93E-023 (01)

SUBJECT: Reese Trailer Hitch Model Number 06070 Safety Recall Campaign

RECALL HITCH 06070 REPLACED WITH 06088

UTILITY HITCH RECALL

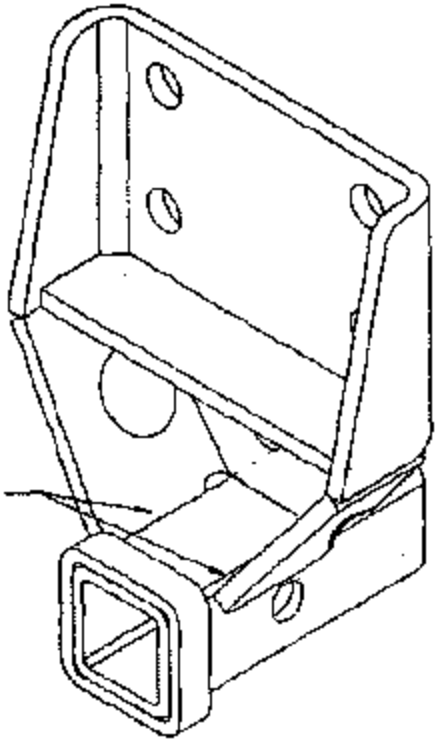
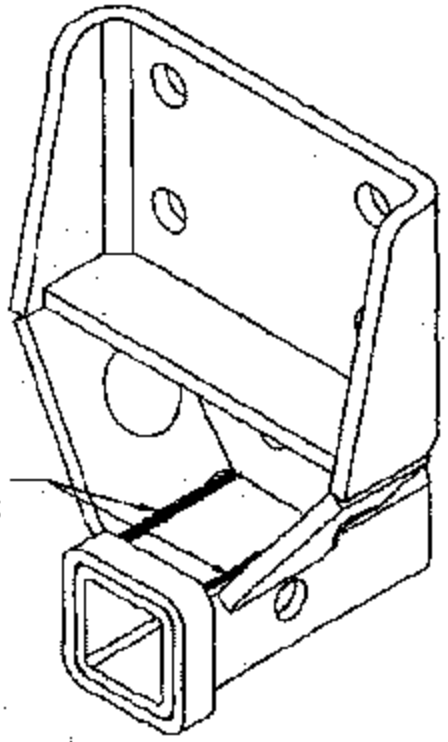
Reese Products, Inc., has determined that a defect which relates to motor vehicle safety exists in certain Class II Insta Hitch Model 06070. The weld material holding the square hitch box to the hitch mounting plate can fail. Failure of this weld could result in serious injury.

Reese Products has determined that a defect which relates to motor vehicle safety exists in certain Class II hitches #06070 (see diagram attached). The weld material holding the square hitch box to the hitch mounting plate can fail. Failure of this weld could result in a serious injury or vehicle crash without prior warning. If the subject hitch has been installed on your vehicle, you are urged to take your vehicle into the dealer from whom you purchased the hitch.

To prevent this condition from occurring, dealers are to install a replacement hitch #06088 which will be provided without charge by Reese. (See diagram)

2. Replace with 06088 following procedure on instruction sheet
